Amendment No. 5

Expand/Construct
Outpatient Mental Health Clinic
Building 111 Addition
Veterans Affairs Medical Center
St. Cloud, Minnesota

VA Project No.: 656-341

AS102 1/8" = 1'-0"

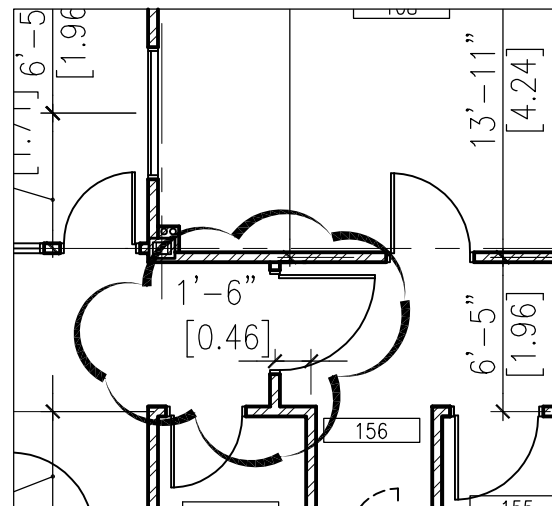
Detail 1/AS102, Door C1-11: Swing of door shall be reversed, relocated wall & handrails modified as indicated on Sheet 111-AS102 Amendment 5 attached.

AS102B 1/8" = 1'-0"

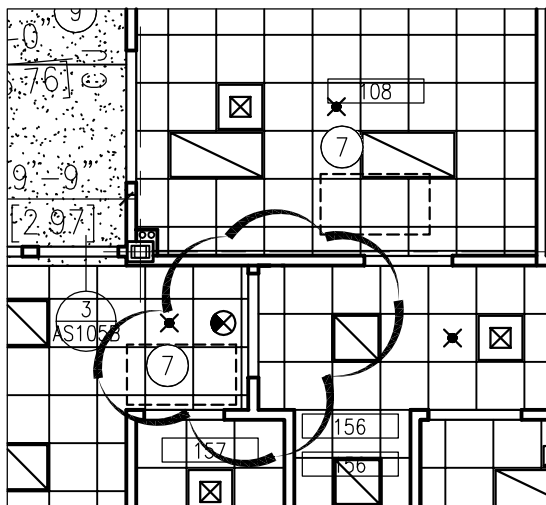
Detail 1/AS102B, Door C1-11; Revise location of wall in clouded area as indicated on Sheet 111-AS102 Amendment 5 attached.
